Amendment No. 1

REBID District VII Overbrook Maintenance Facility

QUESTIONS AND ANSWERS

ASI #1
12/01/2023

FLOOR PLAN
1/8" = 1'-0"

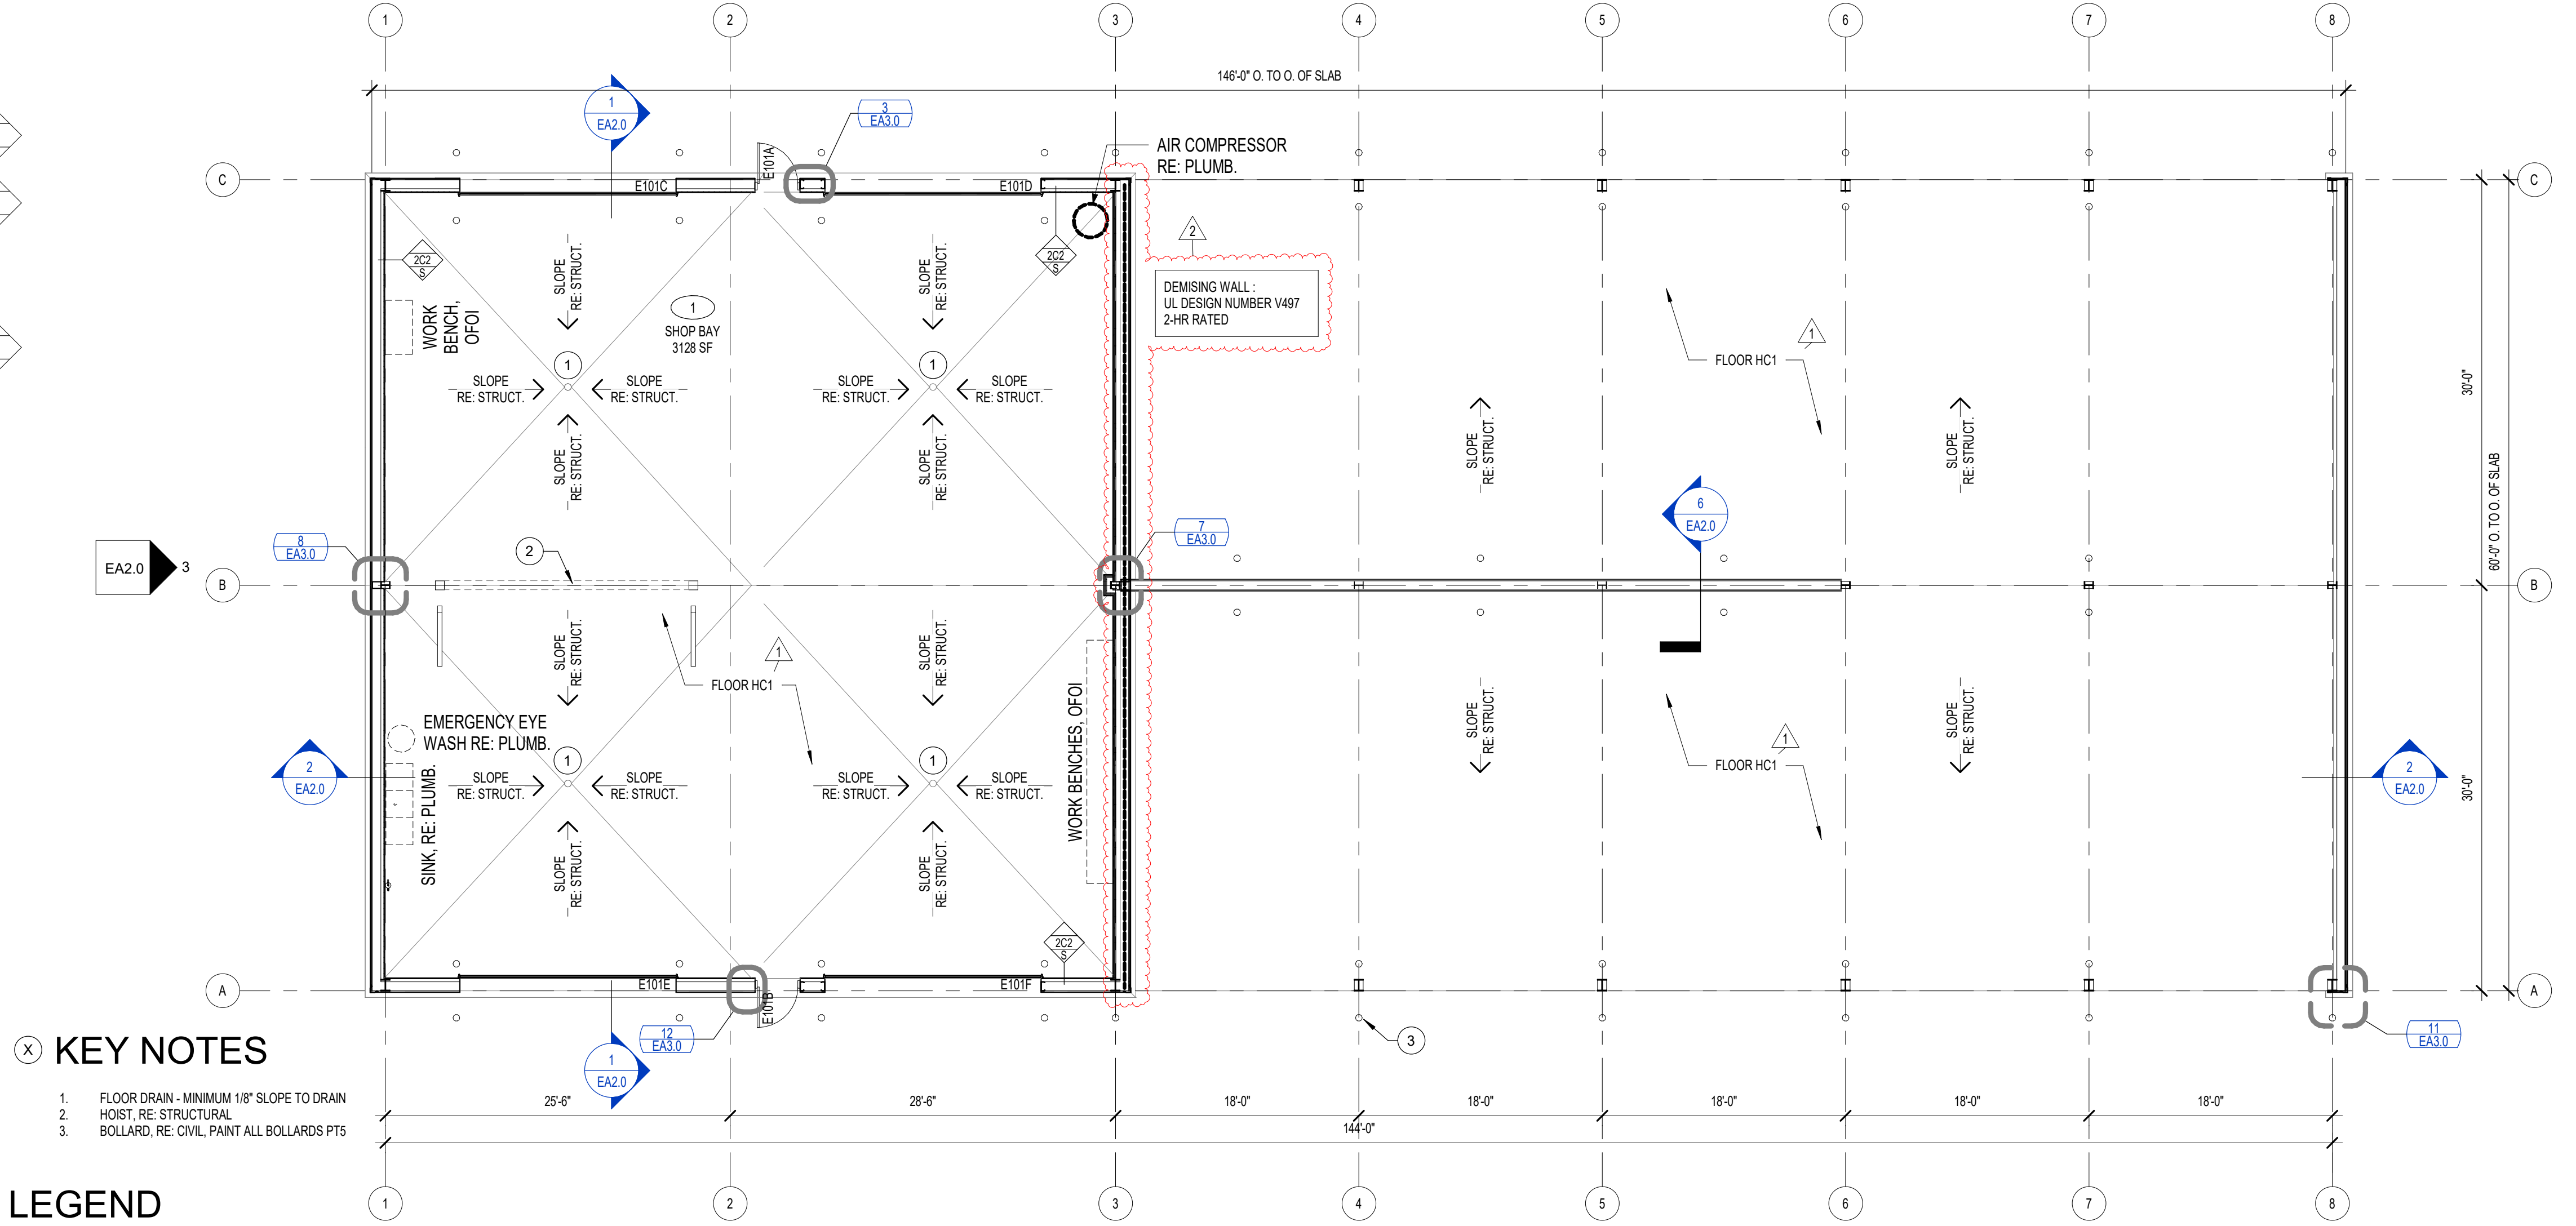
- Description:
1. Sheet EA1.0
 - A. Detail 1 - Revised partition on grid 3.
 2. Sheet EA2.0
 - A. Detail 2 - Revised partition on grid 3.
 3. Sheet EA3.0
 - A. Detail 5 - Revised partition.
 - B. Detail 7 - Revised partition.
 - C. Detail 10 - Revised partition.

3 | PLAN DETAIL
 3" = 1'-0"

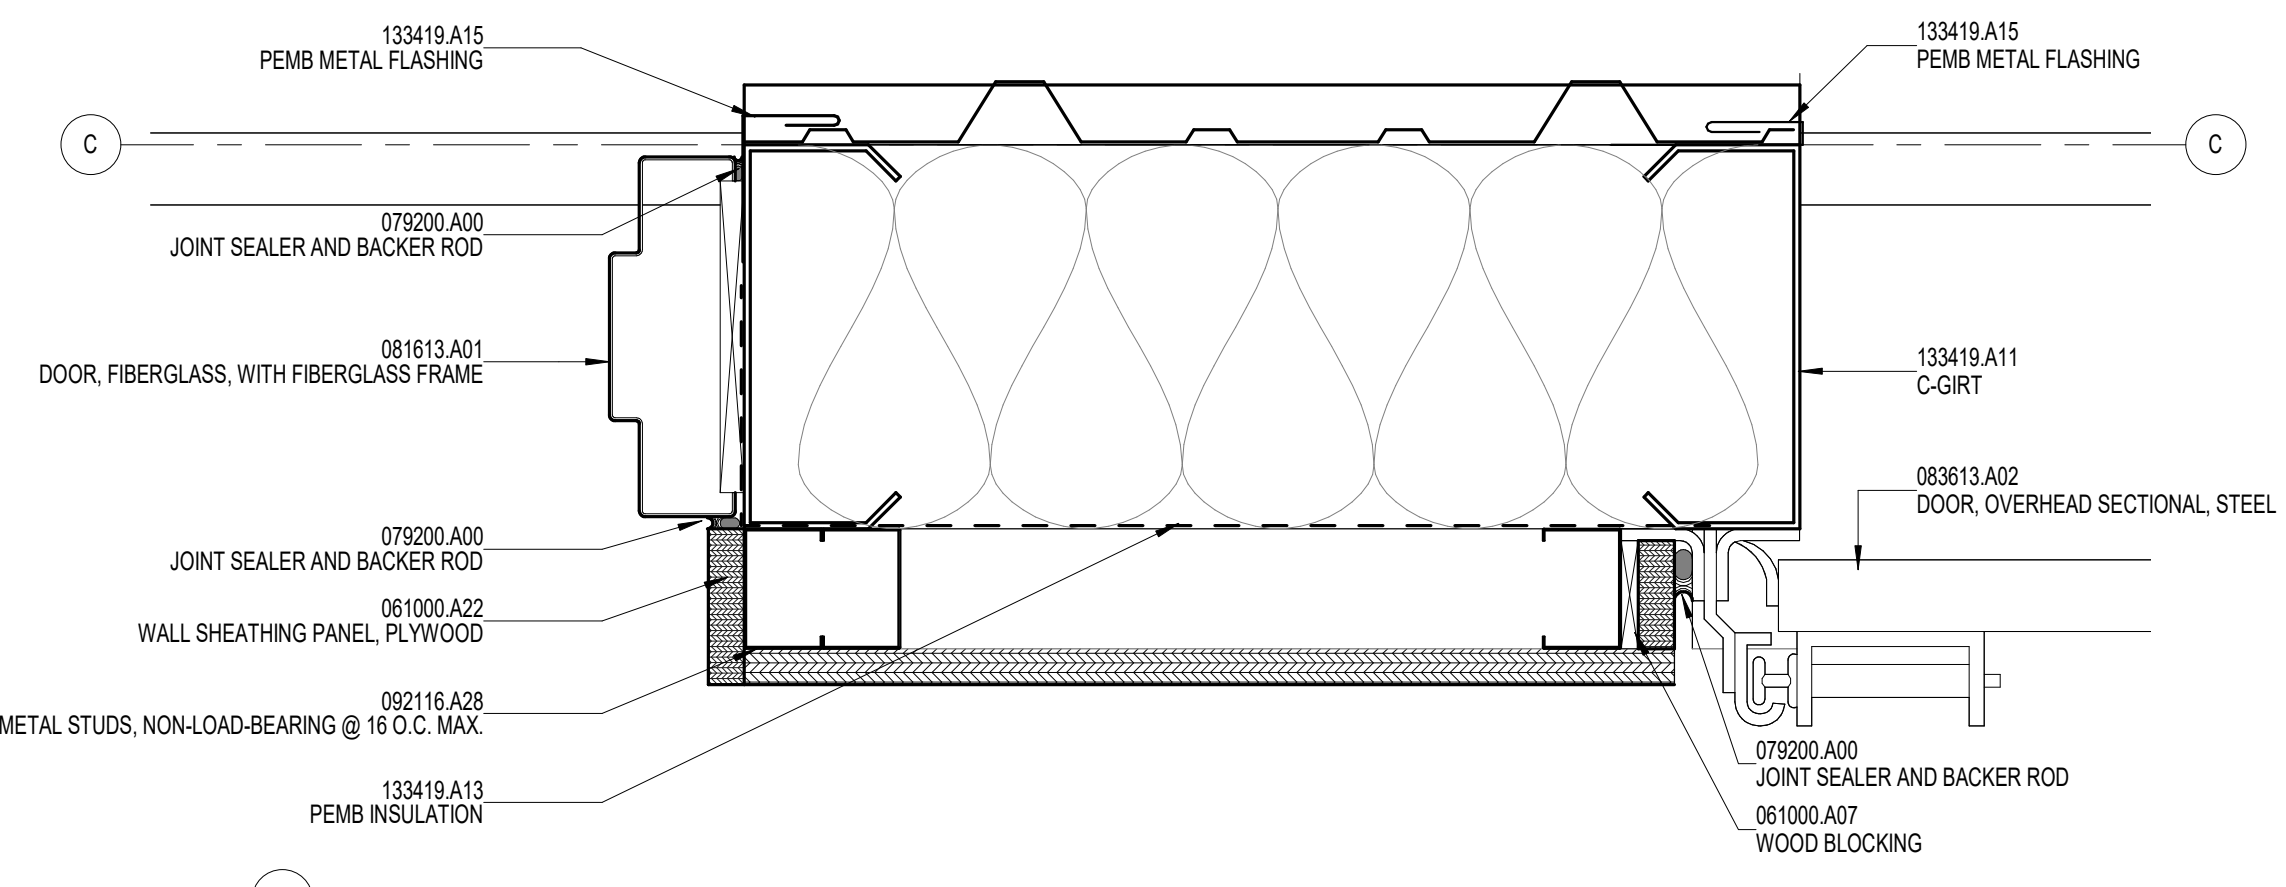
Question No. 6. RFI#4 – Referencing the Door Schedule on page EA1.0 and Detail #3 on page EA3.0: Mark #s E101A and E101B have the door & frame material as Steel but the detail notes them both as FRP. What material applies to these openings?

Answer: Doors and Frames should be steel on Equipment Shed with Shop Bay.

7 | PLAN DETAIL
 1 1/2" = 1'-0"

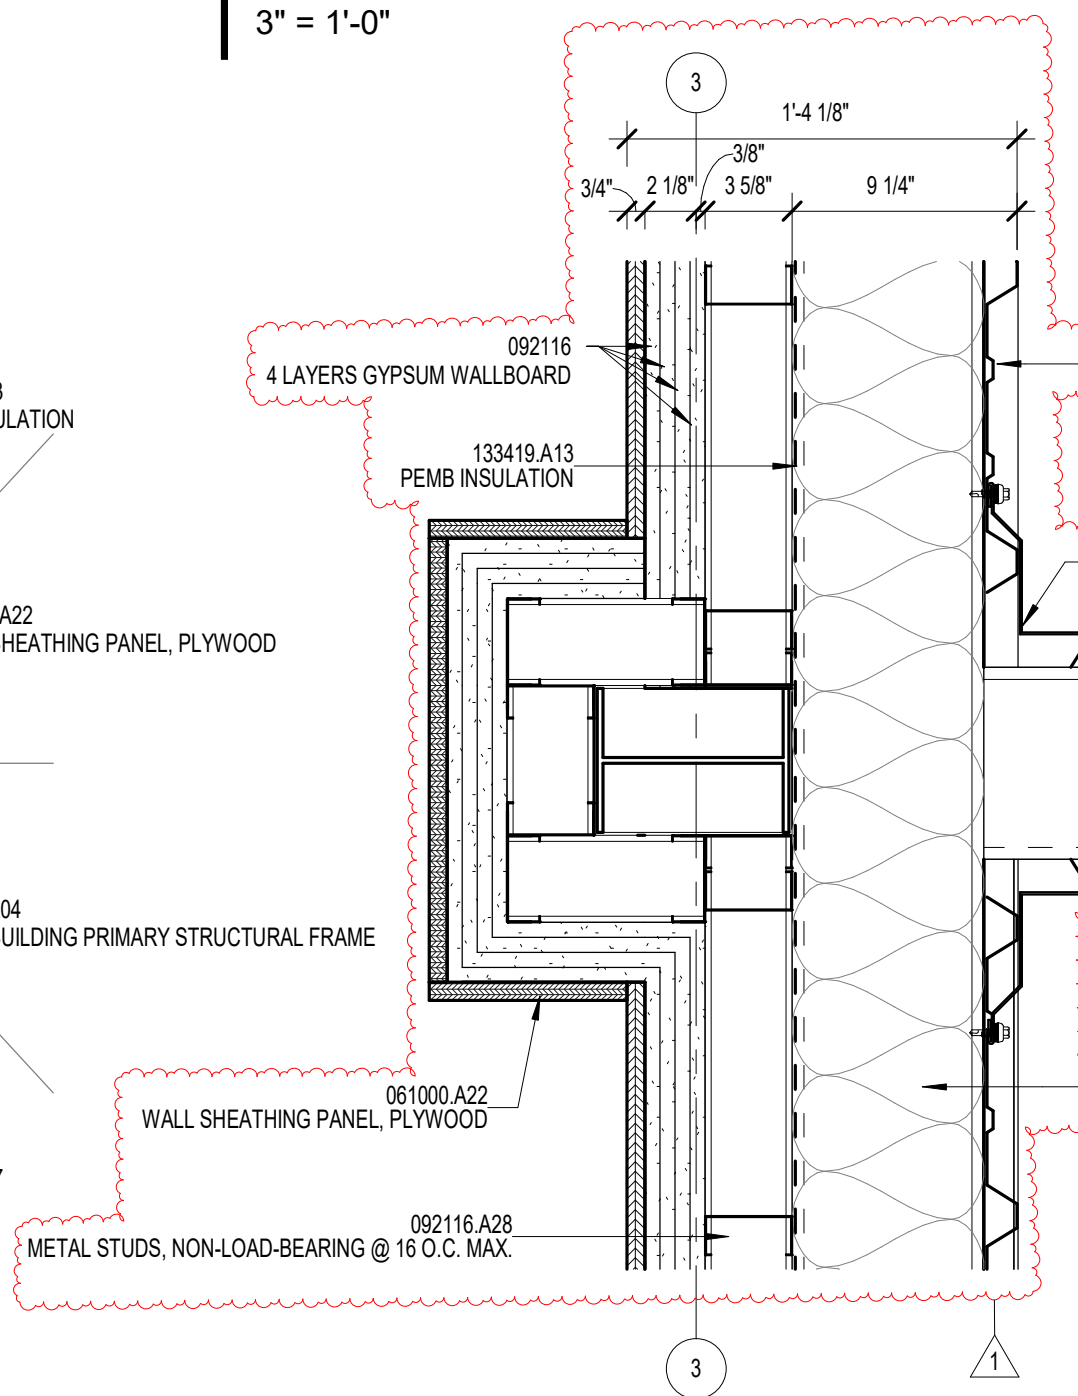
Question No. 10. However, sheet EA3.0 and WA3.0 are in conflict. Details on EA3.0, 1,4,5,6,7,8,& 12 show plywood or metal panels on the walls when the same details on WA3.0 shows a plastic liner panel.

Answer: EA3.0 has plywood and exposed metal panels or liner on the interior, see sections on EA2.0 because it is a shop. WA3.0 has plastic wall panel because of the nature of a wash bay. See sections on WA2.0 for extents of plastic wall panels.
